U.S. Department
of Transportation
Federal Highway

Refer to: HSA-10/WZ-95

THANK YOU FOR YOUR LETTER OF JUNE 6 REQUESTING FEDERAL HIGHWAY ADMINISTRATION (FHWA) ACCEPTANCE OF YOUR COMPANY'S HIGH SAFETYCOR X-TUBE SPEED LIMIT SIGN AS CRASHWORTHY TRAFFIC CONTROL DEVICES FOR USE IN WORK ZONES ON THE NATIONAL HIGHWAY SYSTEM (NHS). Accompanying your letter was a report of crash testing conducted by E-Tech Testing Services along with a video of the tests. You requested that we find this device acceptable for use on the NHS under the provisions of National Cooperative Highway Research Program (NCHRP) Report 350 "Recommended Procedures for the Safety Performance Evaluation of Highway Features."

Illustration 1. High SafetyCor X-Tube Speed Limit Sign (1 of 1)

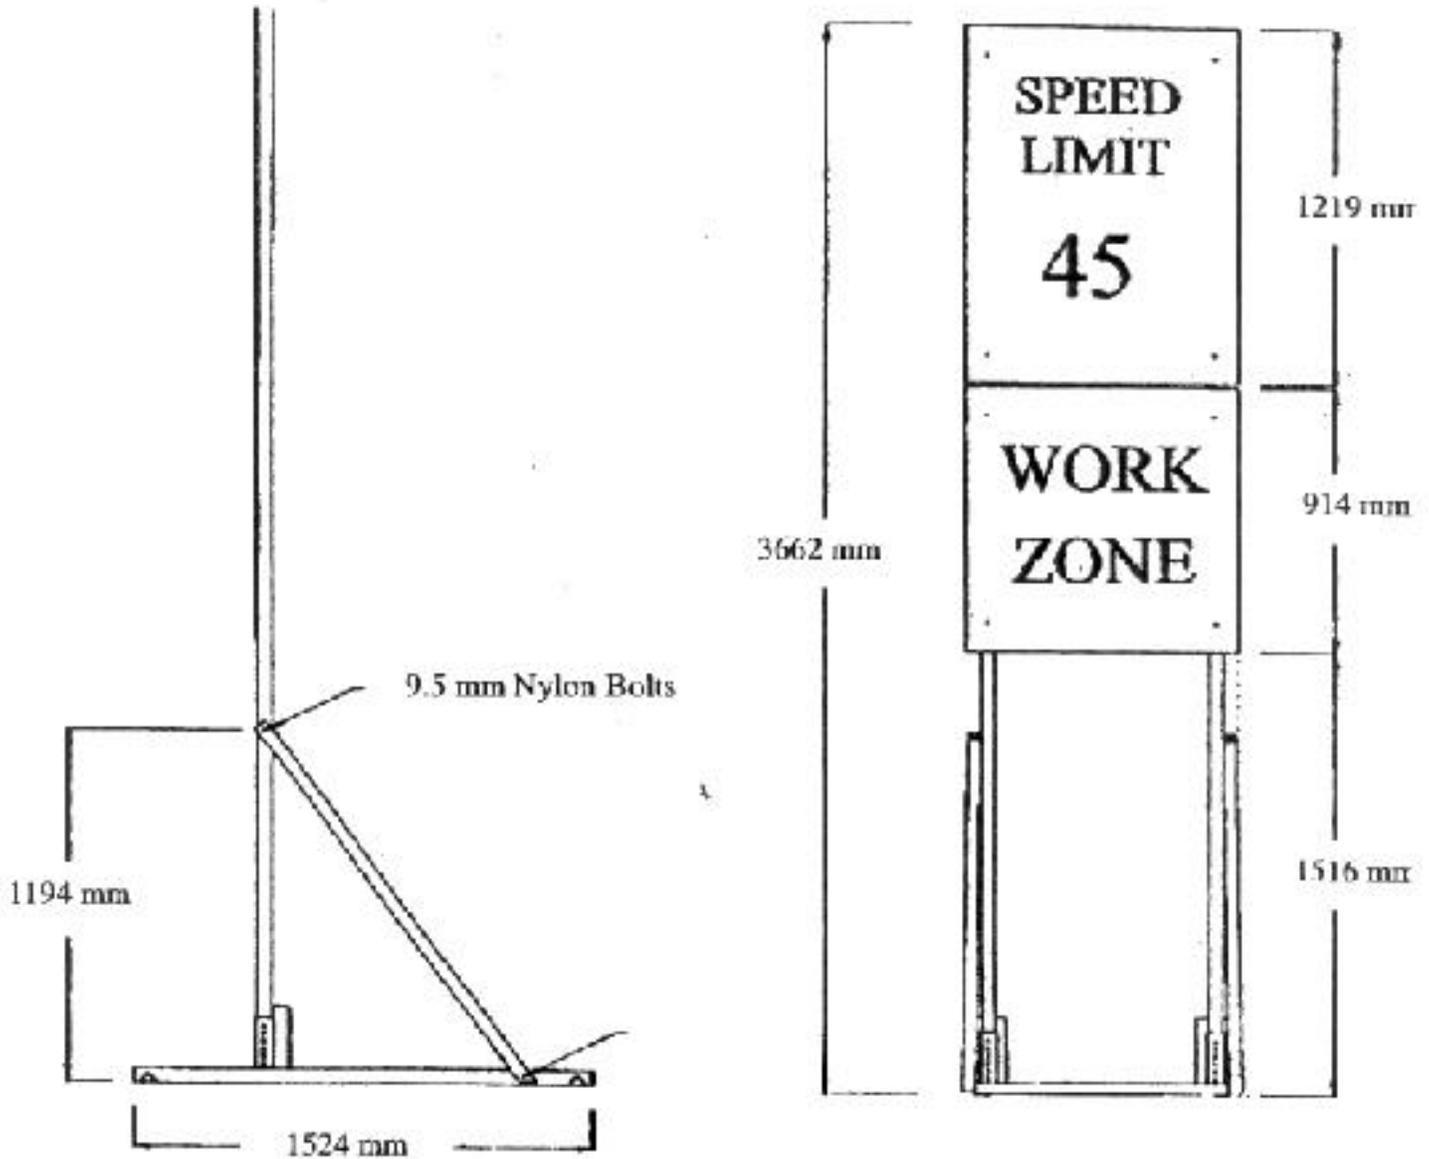
FULL-SCALE AUTOMOBILE TESTING WAS CONDUCTED ON YOUR COMPANY'S DEVICES. TWO STAND-ALONE EXAMPLES OF THE DEVICE WERE TESTED IN TANDEM, ONE HEAD-ON AND THE NEXT PLACED SIX METERS DOWNSTREAM TURNED AT 90 DEGREES, AS CALLED FOR IN OUR GUIDANCE MEMORANDA. THE COMPLETE DEVICE AS TESTED IS SHOWN IN ENCLOSURE 1.

Damage was limited to cosmetic sheet metal damage, with moderate cracking of the windshield. There were no holes or deformation of the windshield glass, nor was the damage extensive enough to impair the driver's visibility. The results of the testing met the FHWA requirements and, therefore, the devices described above and shown in the enclosed drawings for reference are acceptable for use as Test Level 3 devices on the NHS under the range of conditions tested, when
